STAFF REPORT: 07/09/2025 MEETING
ADDRESS: 141 W. BOSTON BOULEVARD
APPLICATION NO: HDC2025-00338
VIOLATION NO: 1023

SCOPE: REMOVE HISTORIC CLAY TILE ROOF,* INSTALL ROOF

141 W. Boston. Photo provided by applicant. Showing metal roofing at rear garage/carriage house's pent roof/canopy, at the west/side façade. The roof at the east/side façade is also covered with metal roofing

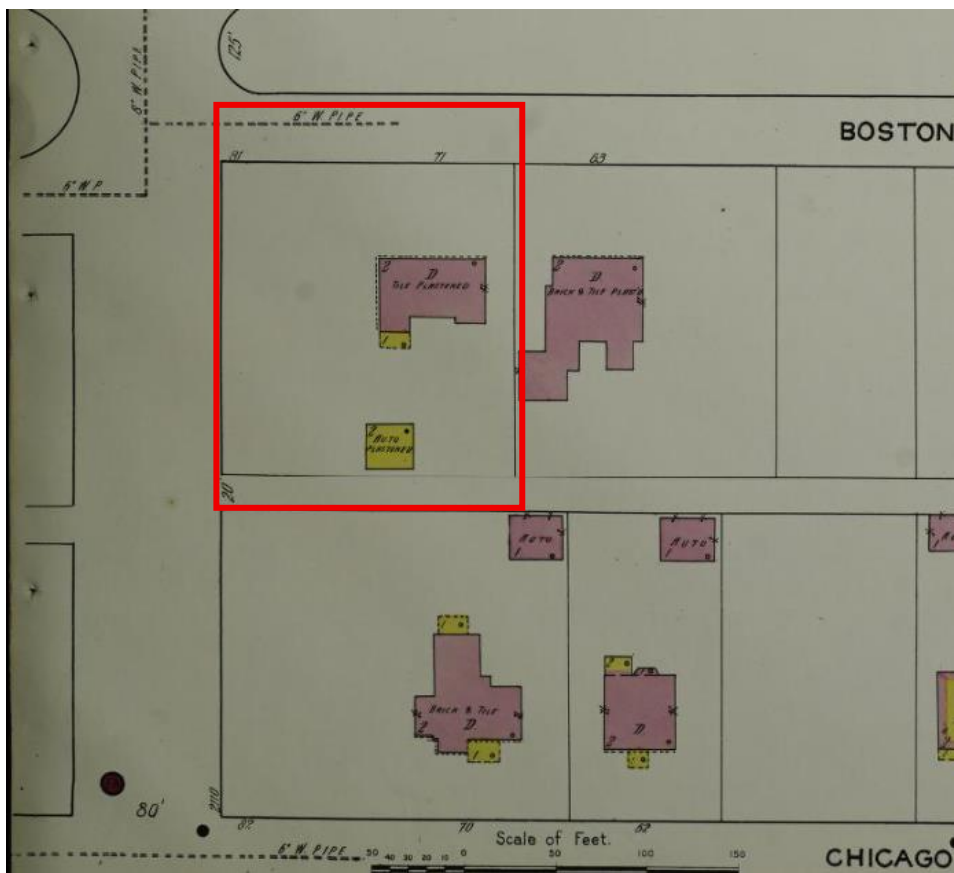
- As noted above, the proposal includes the removal of the remaining clay tile at the garage/carriage house’s front façade pent roof/overhang. Staff notes that the tile at this location appears to be in good condition/does not appear to merit replacement. Therefore, as this tile does remain as a distinctive character-defining feature of the property and is in good condition in staff’s opinion, its removal does not meet the Standards.

- The remaining clay tile at the garage/carriage house’s front façade pent roof/overhang proposed for removal appears to be in good condition/does not appear to merit replacement. Therefore, as this tile does remain as a distinctive character-defining feature of the property and is in good condition in staff’s opinion, its removal does not meet the Standards

- The remaining clay tile at the property's carriage house/garage be retained/shall not be removed

Photo by applicant. Showing condition of clay tile

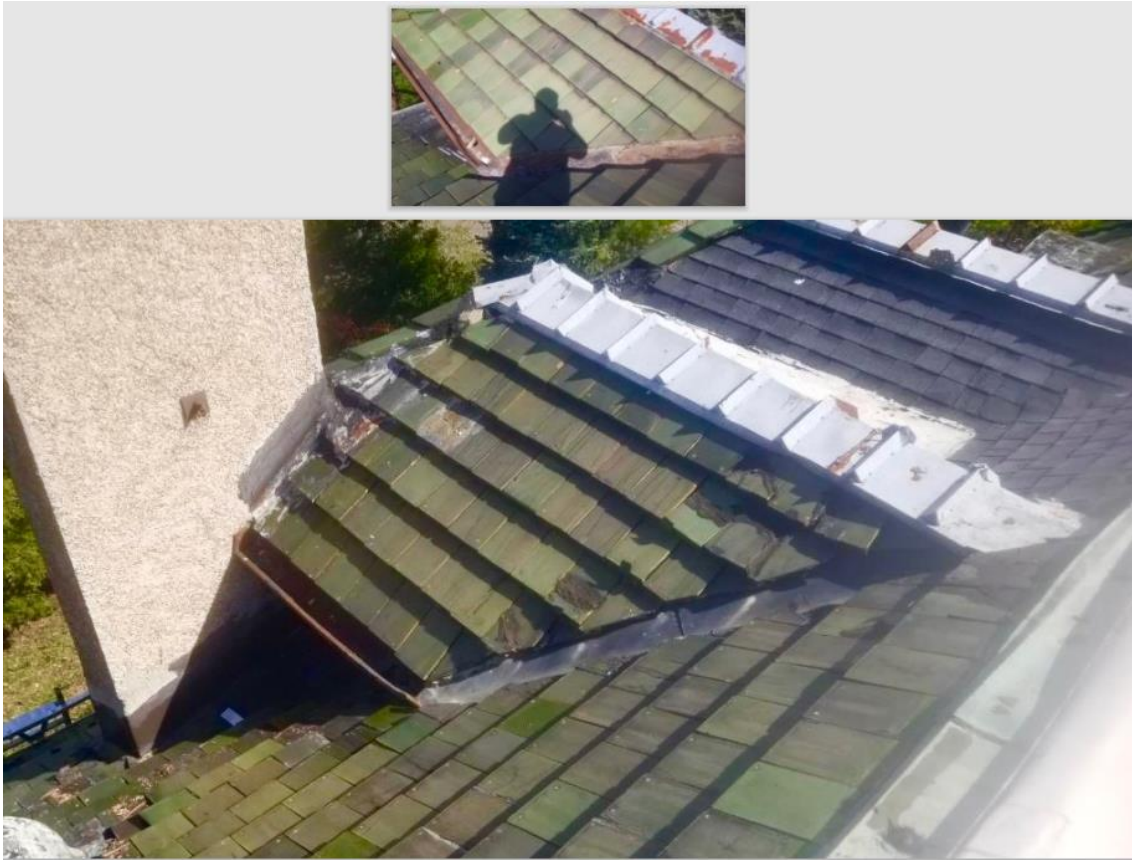
- Staff did review the condition report of the house's roof which has been submitted with the current application and concluded that this 115-year-old roof does appear to merit wholesale removal and replacement. Specifically, the roof does appear to suffer from broken, deteriorated, and missing tiles throughout; numerous unapproved past repairs; and unapproved replacement of sections of tile roofing with asphalt shingles at the front dormers and the rear of the roof. However, the application does not include documentation/which indicates that the clay tile roof at the garage merits repair. An assessment of the garage roof's remaining clay tiles from the public right-of-way,

West side dormer, clad with slate, painted green. Photos provided by applicant

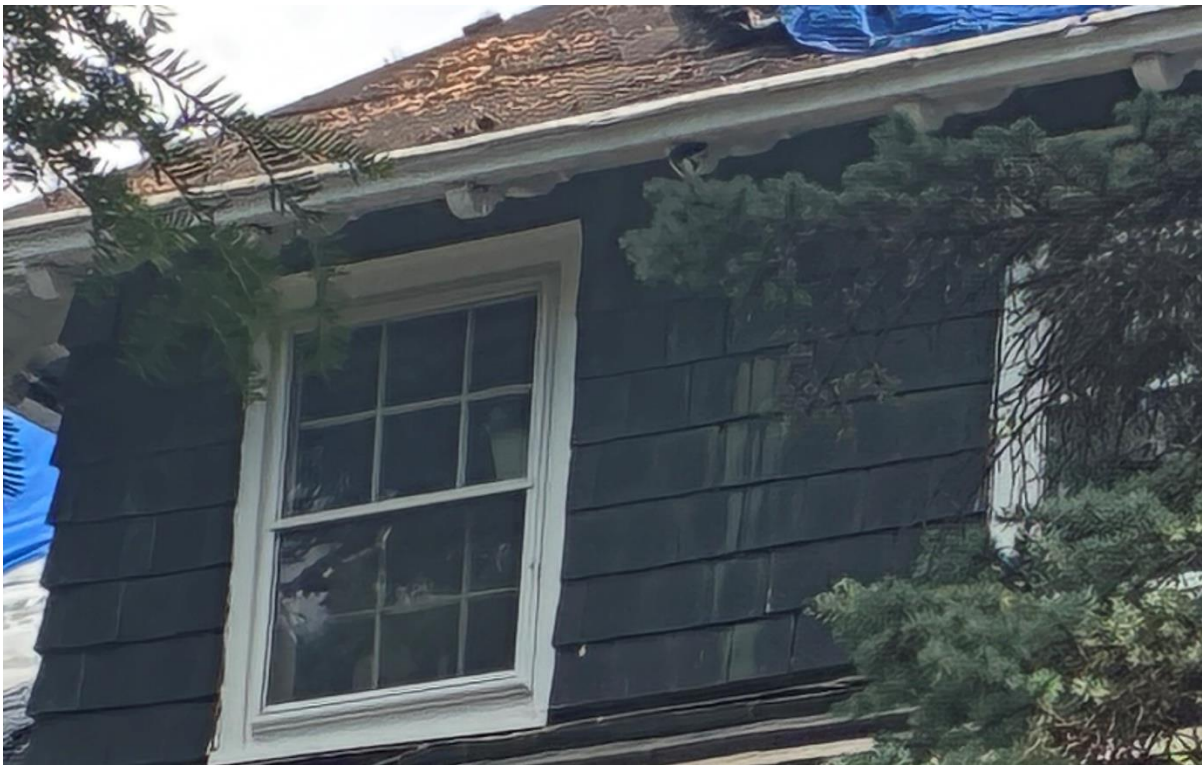
- The applicant has provided photos that indicate that one of the rooftop dormers, located at the west side, has slate shingles at the front and side walls. The shingles at this dormer have been painted green to match the clay tiles at the main roof surface. However, staff does note that double dormer at the front/primary façade is clad with clay tiles. See the photos below for current conditions.

- As previously noted, one of the dormers, at the side elevation, is currently clad with slate tiles which have been painted green. The primary/street facing double dormer is clad with slate tiles. While the slate at the west side dormer is likely historic age, it has been painted green, presumably in an effort to match the appearance of the clay tile found at the main roof surface and the primary double dormers which are located at the front façade roof surface. Also, it is likely that the slate was not original to the house’s construction. Given the cumulative/overall result of the installation of a new clay tile roof at the property, it is staff’s opinion that the replacement of slate with clay tile at the west side dormer’s front and sidewalls would be a reasonable and appropriate approach.
